<b>Docket Number:</b>	01-AFC-07C
<b>Project Title:</b>	01-AFC-7C Russell City Energy Company
<b>TN #:</b>	224019
<b>Document Title:</b>	Applicant's Responses to Staff's Data Requests, Set 1, A1 through A15
<b>Description:</b>	N/A
<b>Filer:</b>	Deric Wittenborn
<b>Organization:</b>	Ellison Schneider Harris & Donlan LLP
<b>Submitter Role:</b>	Applicant
<b>Submission Date:</b>	6/29/2018 1:49:15 PM
<b>Docketed Date:</b>	6/29/2018

RE: Docket No. 01-AFC-07C: Petition for Modification  
Responses to Staff's Data Requests, Set 1, A1 through A15

## RESPONSES TO STAFF'S DATA REQUESTS, SET 1, A1 THROUGH A15

**ATTACHMENT DR-A10**

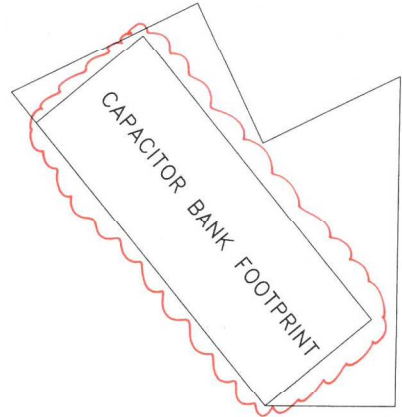
**A10. Please note on the site plan (Figure 1) the location of the proposed laydown and parking area(s) and describe the surface conditions and whether any ground disturbing activities would occur at the location(s).**

**RESPONSE:** For construction the areas for parking and laydown are shown on Attachment DR-A10. The site surface for temporary parking and laydown is gravel and there are no ground disturbing activities expected at that location. For operations, no new parking locations are proposed because existing parking spaces around the main administrative building (directly north of switchyard) will be utilized.

**ATTACHMENT DR-A12P**

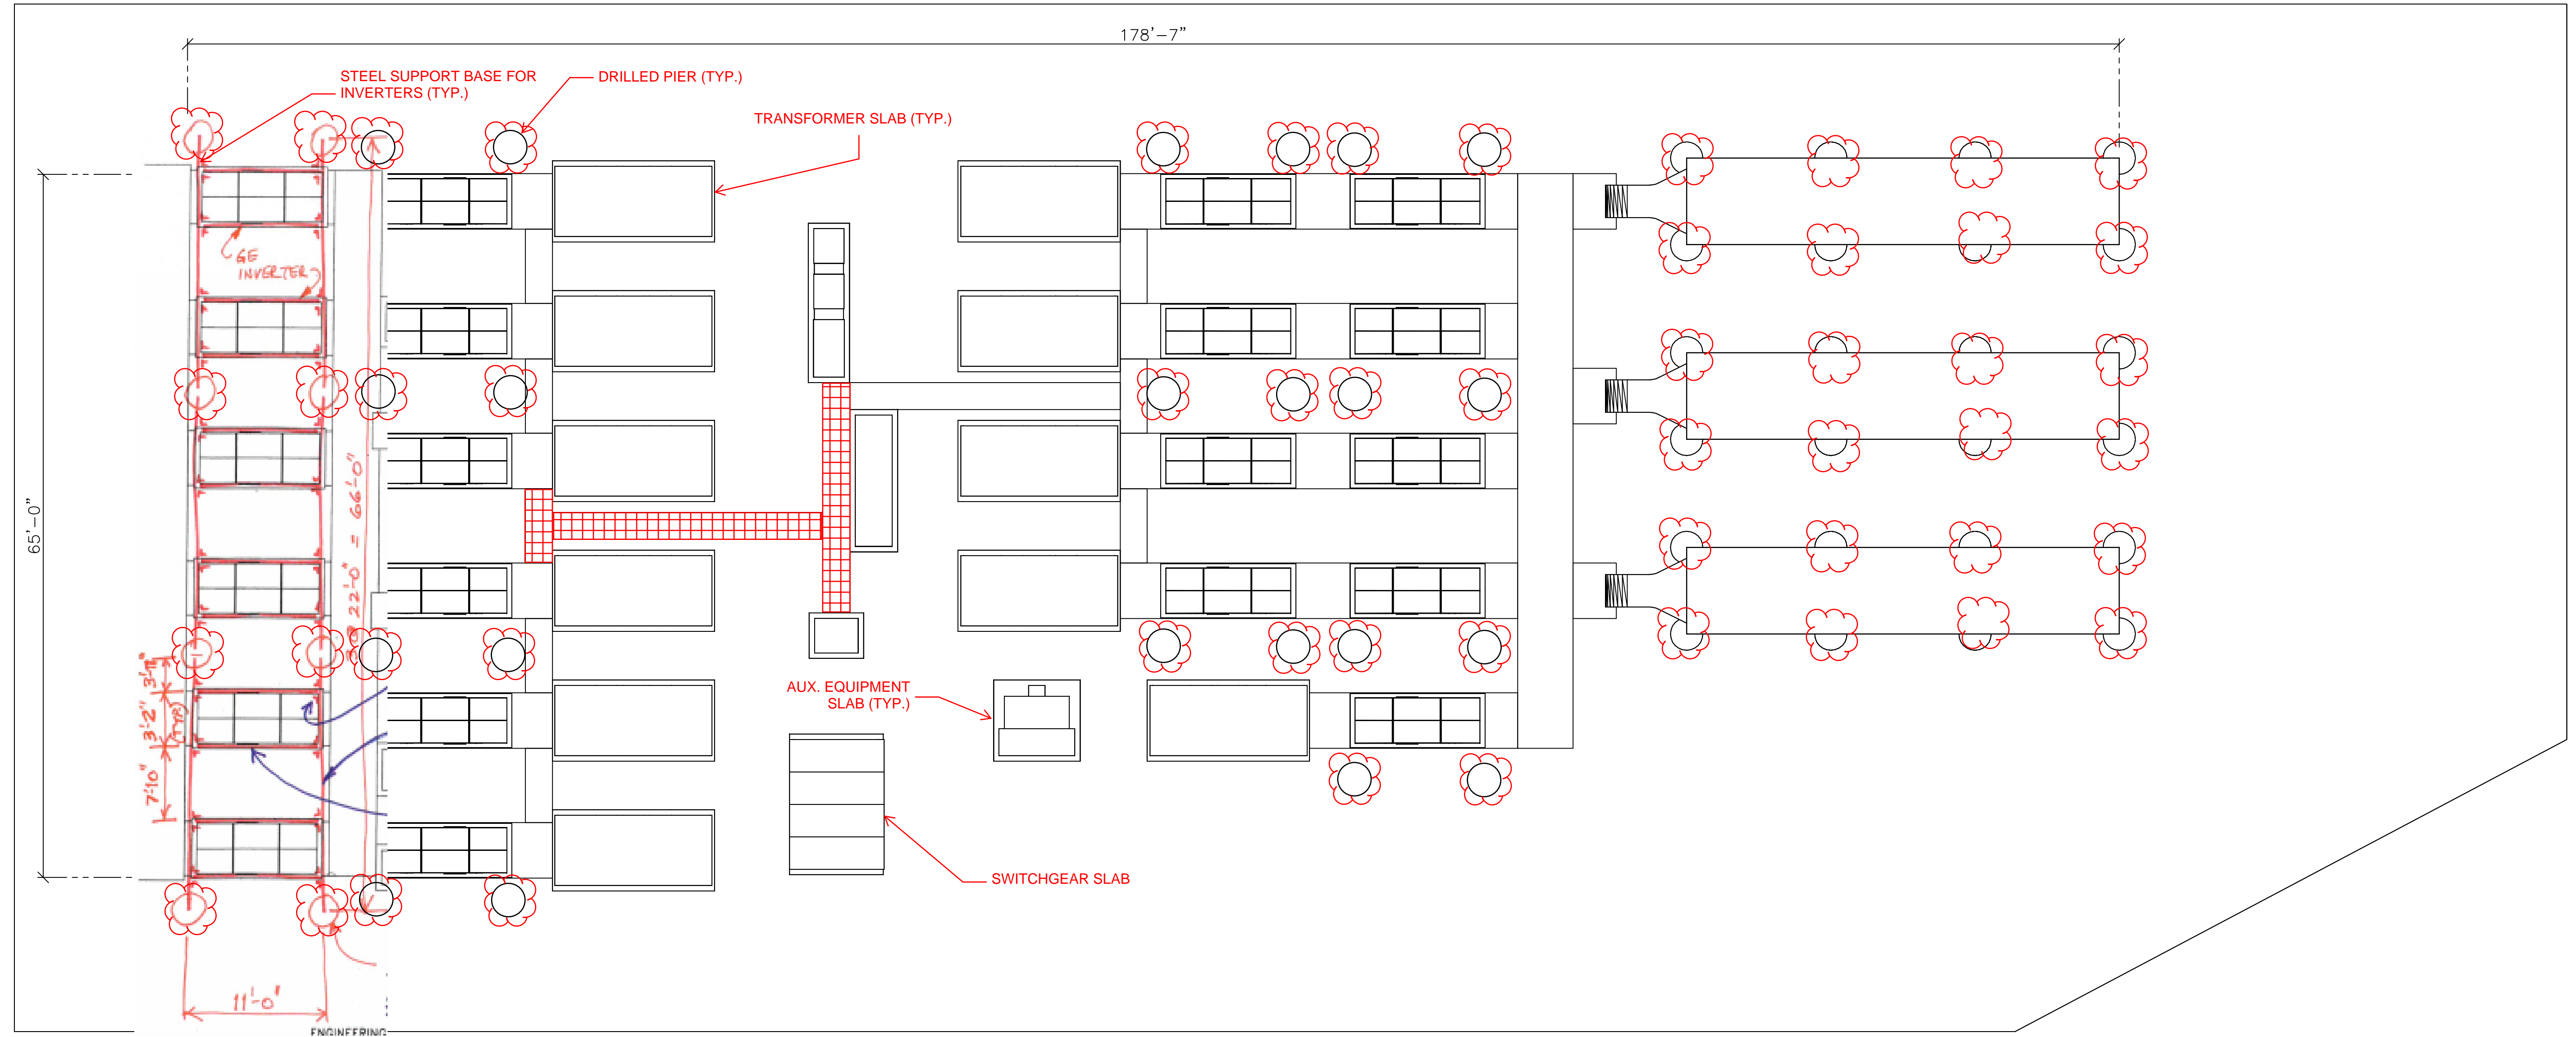
**A12. Please provide a plan showing the footprint of the proposed area of excavation and cross-section of excavations that will be required for foundation construction.**

**RESPONSE:** Attachment DR-A12P (primary site) and Attachment DR-A12S (secondary site) show the estimated footprint and cross-section of excavation for foundation construction.

**ATTACHMENT DR-A12S**

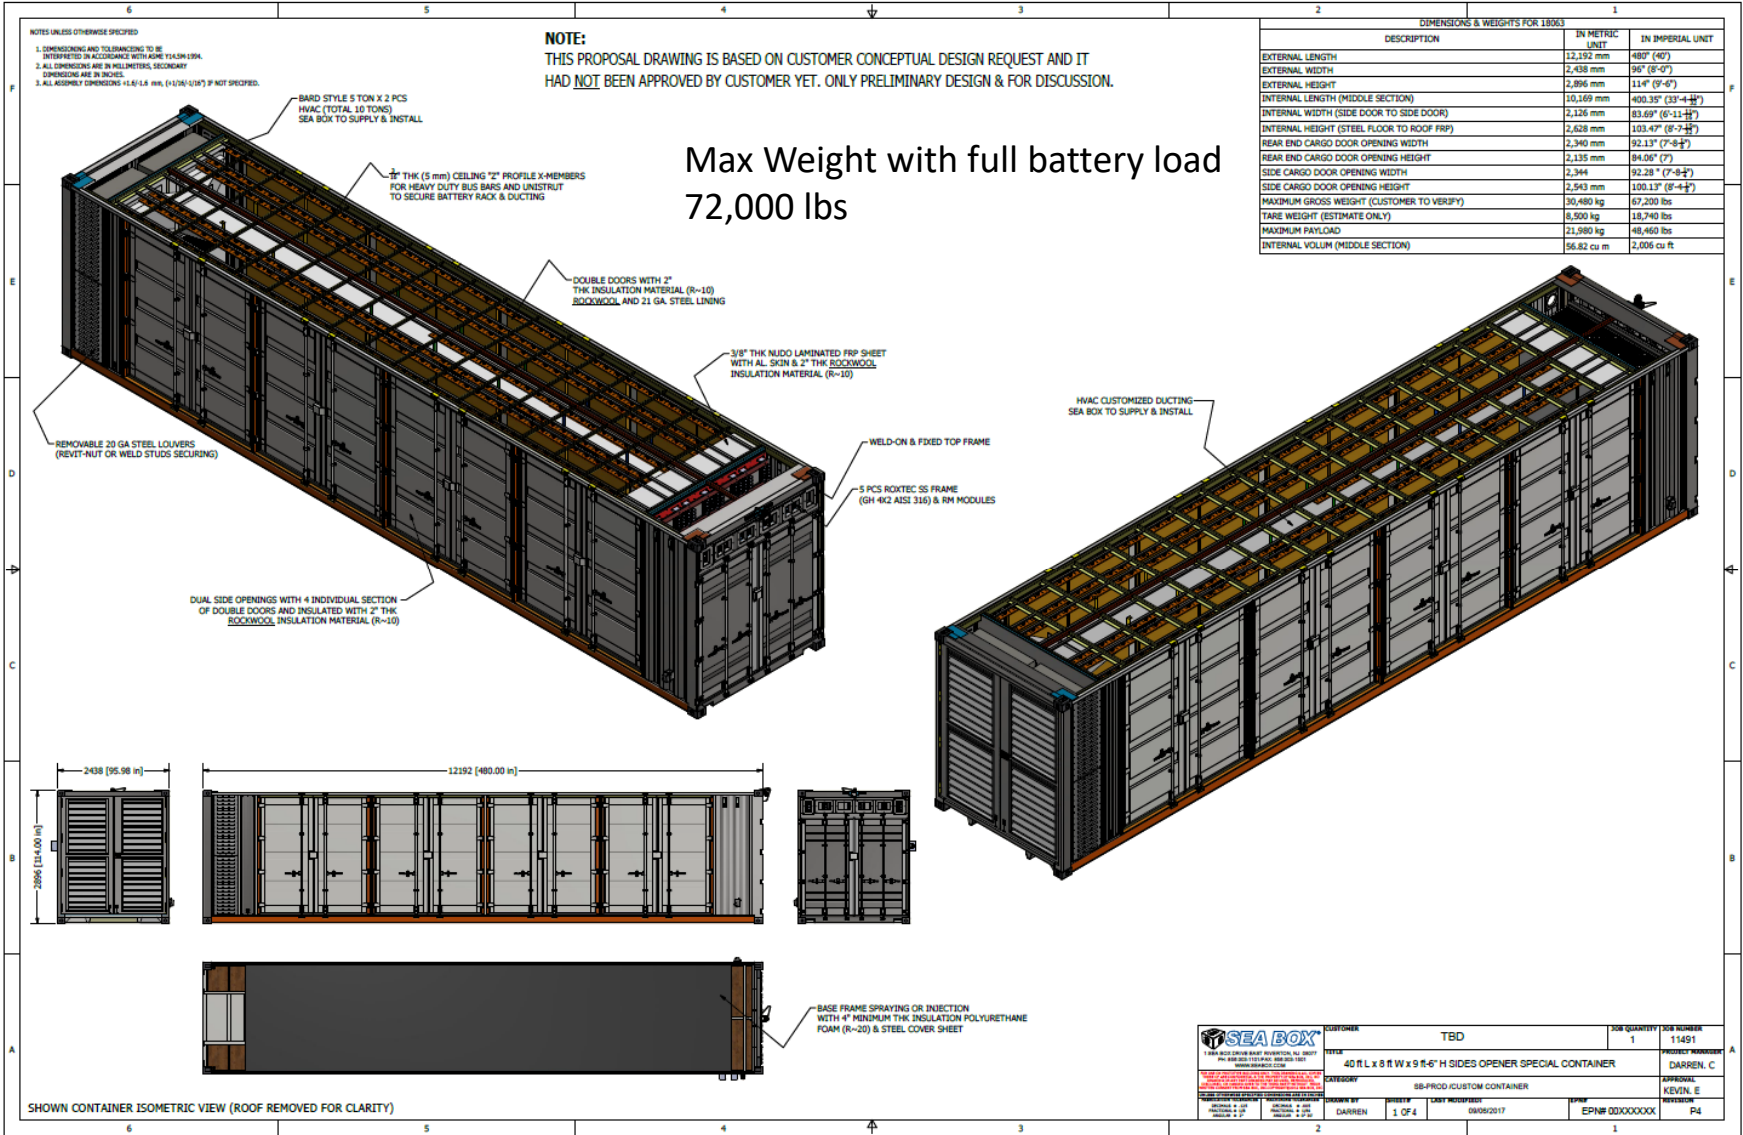
**A9. Please note and label on the site plan (Figure 1) the areas where additional ground-disturbance beyond the concrete pad is proposed (see# 1 above).**

**RESPONSE:** Please see Attachments DR-A9P and DR-A12S, which modify Figures 2 and 3 to show the expected areas where ground-disturbance beyond concrete would occur. Attachment DR-A9P represents the primary site while Attachment DR-A12S attached represents the secondary (north) site.
